**BUCKEYE CARIBBEAN TERMINALS, LLC**

**Re: Coastal Zone Certification**  
**NPDES Permit Application Revision No. 2**  
**Permit No. PR0000400**  
**Buckeye Caribbean Terminals LLC**  
**Yabucoa, Puerto Rico**

FIGURE NO. 2

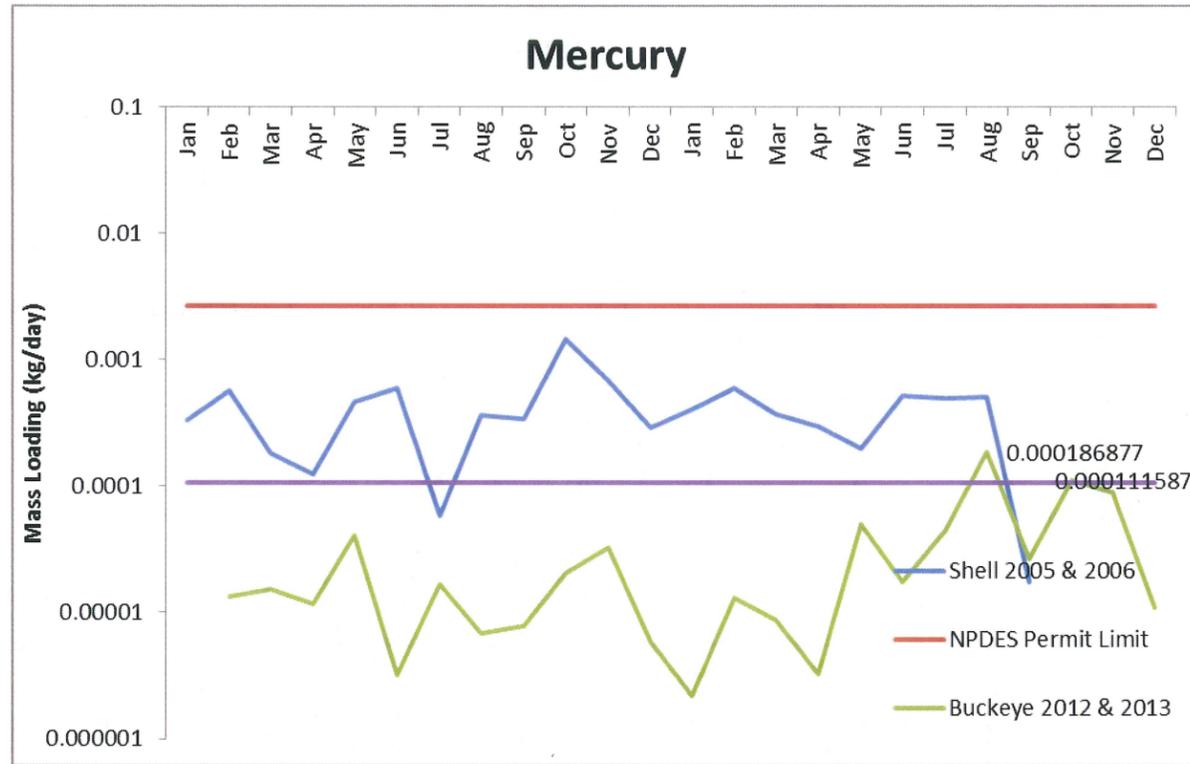
operation pursuant to the ACO. However, the Draft WQC imposes a compliance limit of 8.28 µg/l. Figure No. 3 shows the nickel mass loadings for the Facility's discharges in 2005 and 2006 when the refinery was in operation compared to the Facility's discharges in 2012 and 2013 when all refinery operations had ceased. Figure 3 also shows the NPDES effluent limitation and Draft WQC limit converted to allowable mass loadings.

FIGURE NO. 4

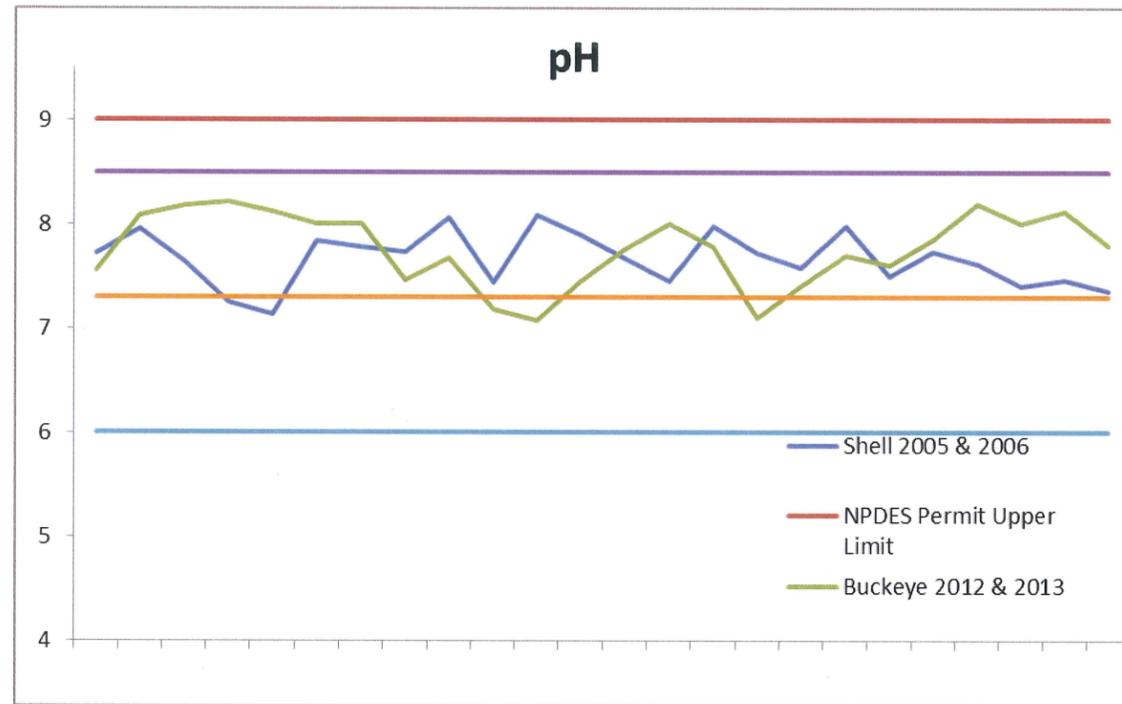
<sup>16</sup> See, **Figure No. 4**.

4. **pH** - The Draft WQC would require compliance with a lower level pH limit (7.3) approximately 22% higher than that currently required under the ACO and the previous NPDES permit (6.0), and a higher level pH limit (8.5) approximately 6% lower than the current limit (9.0). Figure No. 4 shows the pH results for the former and current discharges during the mentioned reporting periods. The figure reflects quite similar results for both facilities over different time periods. BCT would not be able to meet the pH limit during the dry season if the proposed new limits are established. BCT sees no reason why such stricter lower pH requirement is necessary, particularly when the receiving water system is the Yabucoa Bay where its depth, currents, temperature, salinity, and other parameters have a direct influence over the pH content. Further, the Benthic Study does not attribute any harmful effect on the bay's environmental conditions originated by BCT's discharges' pH content. On the contrary, the study concludes that any damage to the bay's macrobenthic population near the Outfall is due to external factors not related to BCT's discharges. Considering that BCT's current flow is significantly less than that of its former operation, in addition to the dilution provided by the bay serves as a natural neutralization agent, the current discharges' quality will not be detrimental to the water receiving body.

<b>WATER BALANCE</b>	<b>ATTACHMENT 9</b>
----------------------	-------------------------

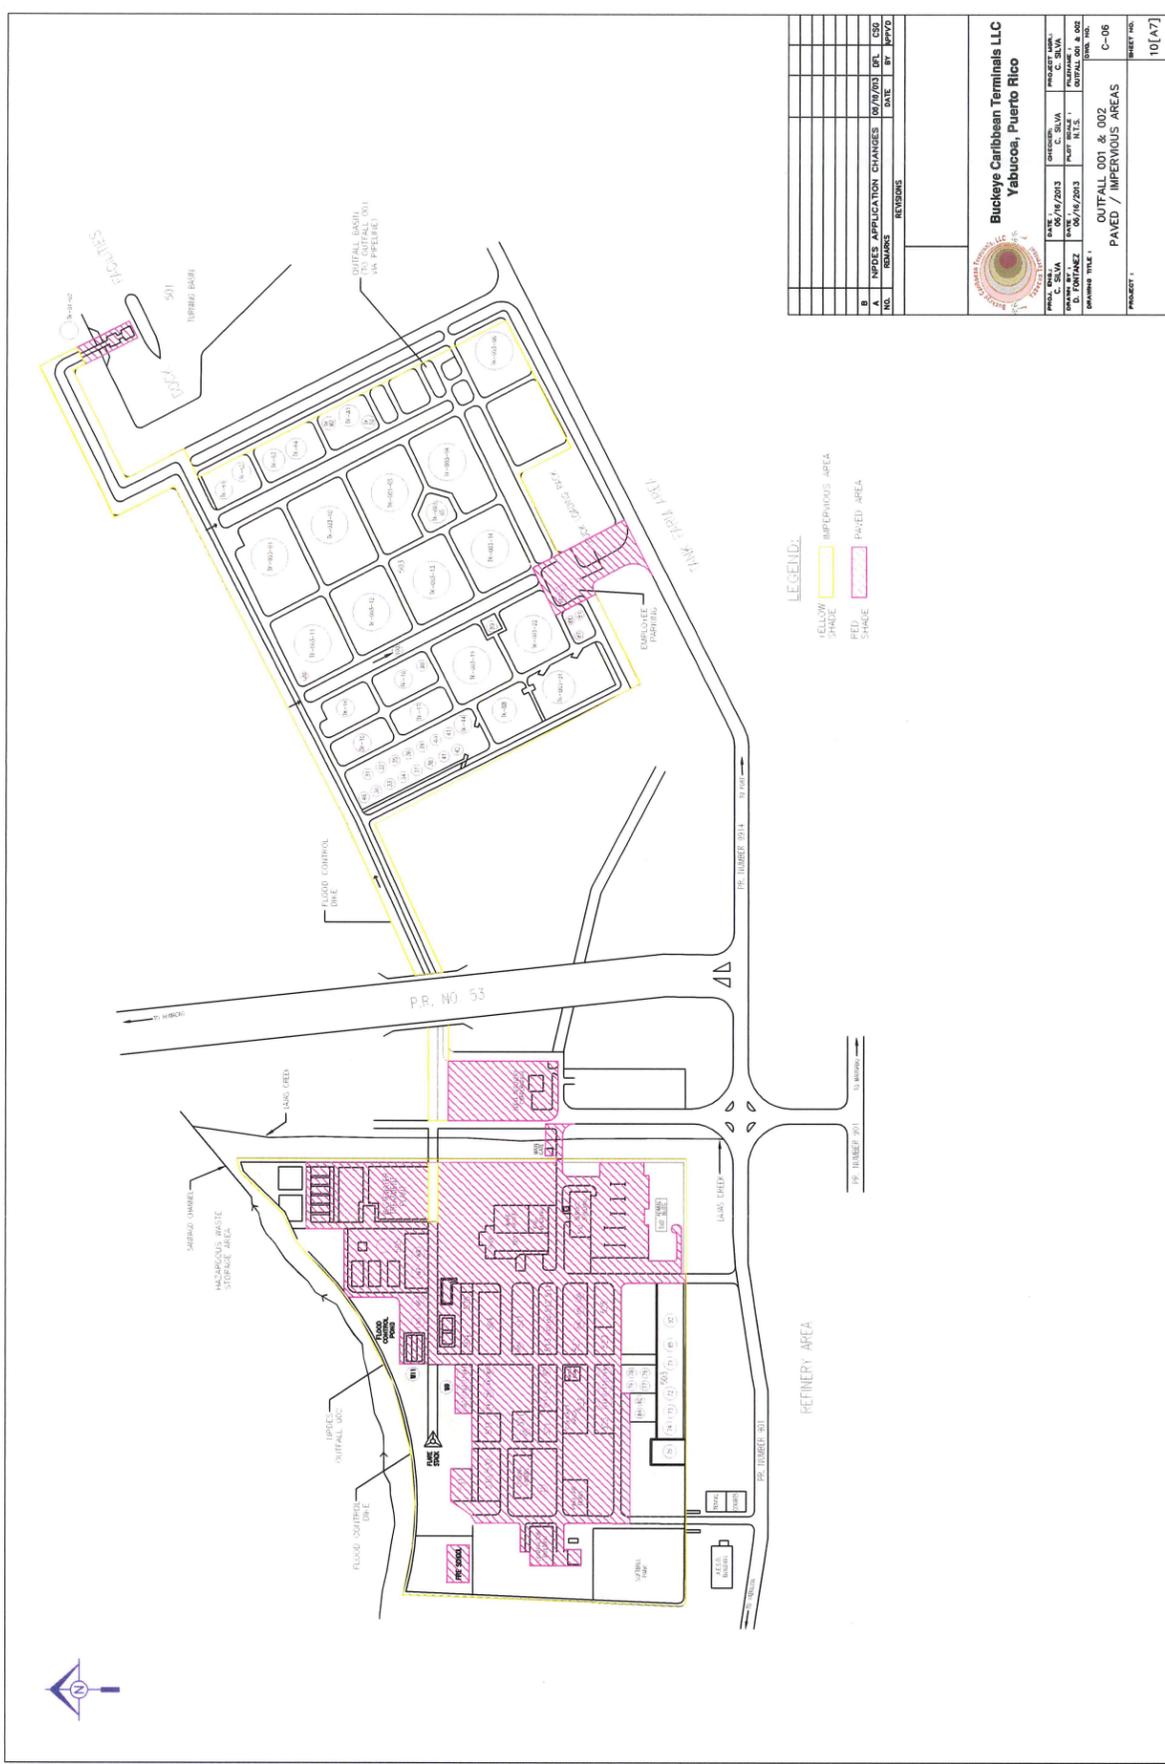
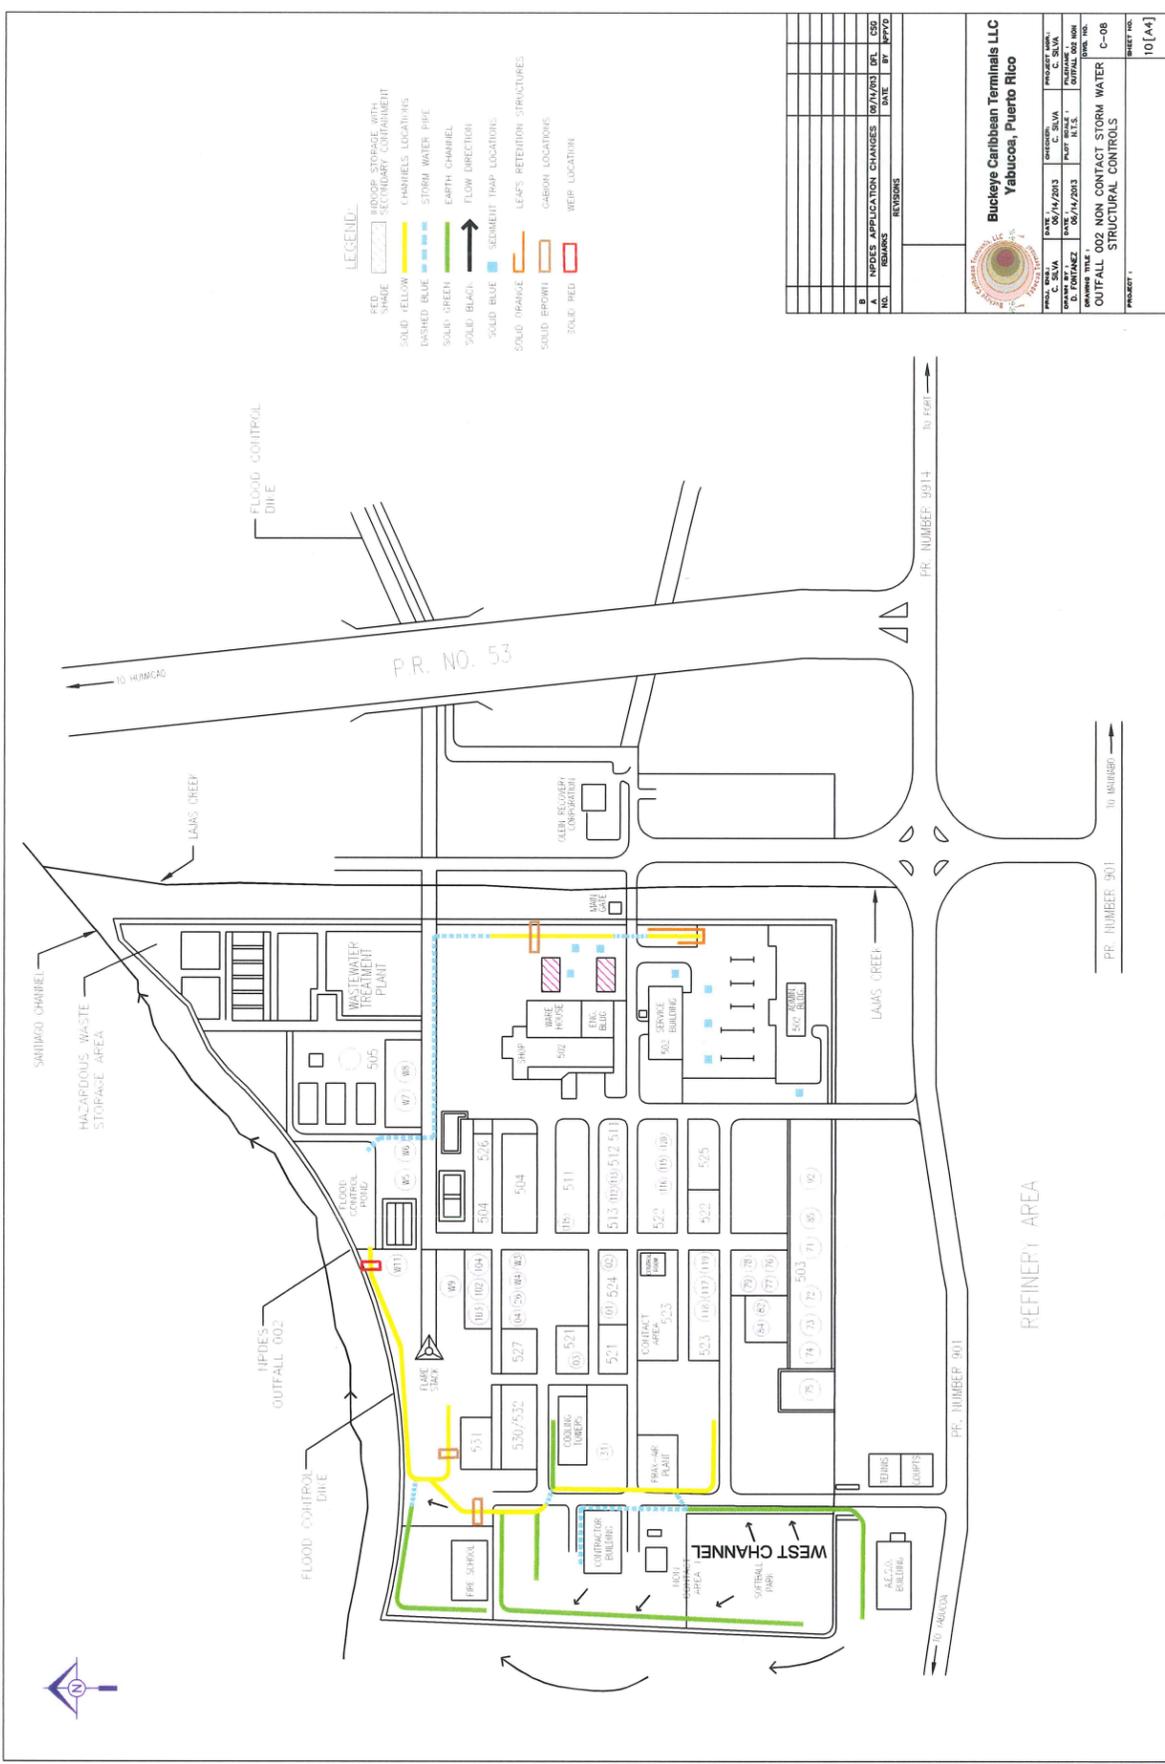
1. Item IIA- Application Form 2C, Item II.A requires a line drawing to be attached. For Item II.A, EPA reviewed the line drawing shown in Attachment 9 entitled "Water Balance - Current Conditions, Buckeye Caribbean Terminals LLC". The line drawing must also indicate treatment units. As such, EPA also reviewed Attachment 8 (entitled "Waste Water Treatment Plant Units, Buckeye Caribbean Terminals LLC") since it also shows water flow through the facility and treatment units (in more detail). The following deficiencies must be addressed:

- b. Water Flow Through the Facility - Show if Refinery WWTP Treats Sanitary-  
The water balance in Attachment 9 does not show sanitary wastewater (Domestic) being treated in the refinery WWTP but instead it shows it as being treated in the DAVCO WWTP:

- a. Item II.B.2.a Operations - Caño Santiago (Infiltration) - The line drawing in Item IIA (Attachment 9) of the application shows the operation "Caño Santiago Infiltration" with a flow of 1.4 kgpd:

Flushing and Air Conditioner Condensate- The line drawing in Item II.A (Attachment 9) of the application shows the following material balance around the "Tank Farm":

However, it does not show how the incoming flows to the tank farm are divided between the flows exiting the tank farm.

However, Item II.B.3 appears to show that the 0.666 kgpd flow from these operations go to the "Tank Farm API and WEMCO Treatment" as follows:

Therefore, the application must clarify how the flows that enter the tank farm are treated. Specifically:

- the application must clarify whether the 0.4 kgpd Olein Runoff, 0.16 kgpd Fire Drill Water, 0.1 kgpd Fire Hydrant Flushing and 0.006 kgpd Air Conditioner Condensate s all go to the "3-cell" API Separator for treatment or whether a portion of any goes to the "Tank Farm API and WEMCO Treatment" or for "Marine Vessel" or "Septic Tank" use.

- the application must clarify whether all of the 360 kgpd storm runoff from the tank farm goes to the "API Separator and WEMCO" or whether a portion goes to the "3-cell" API separator or for "Marine Vessel" or "Septic Tank" use.

- the application must clarify whether the entire 7.3 kgpd "Potable Water PRASA from the tank farm goes entirely to "Marine Vessel Use" and "Septic Tank Use" or whether a portion goes to either the "Tank Farm API and WEMCO Treatment" or "3-cell" API Separator.

Tank water drains from Tank Farm goes either to the 3-cell or the 2-cell API separators. Attachment 8 (Description of Treatment Units, Attachment 9 (Water Balance Diagram), and Form 2-C for outfall 001 of the NPDES revised application were modified.

Refinery's WWTP does not treat sanitary waste waters (Domestic). DAVCO package wastewater plant treats domestic waste waters. Explanatory Memo in Attachment 2 was modified to add clarity.

The total into 3 Cell API Separator Unit (in kgpd) include 0.16 from Firefighting Drills +0.60 from Pavement Washings+ 98 from Closed Refinery+ 5 from Future Demolition + 0.015 from Tank Farm drains= 103.770 kgpd. The 0.666 kgpd goes to API Separator and WEMCO instead of 3 Cell API Separator. Attachment 9 (Water Balance Diagram) was modified to show the correct numbers.
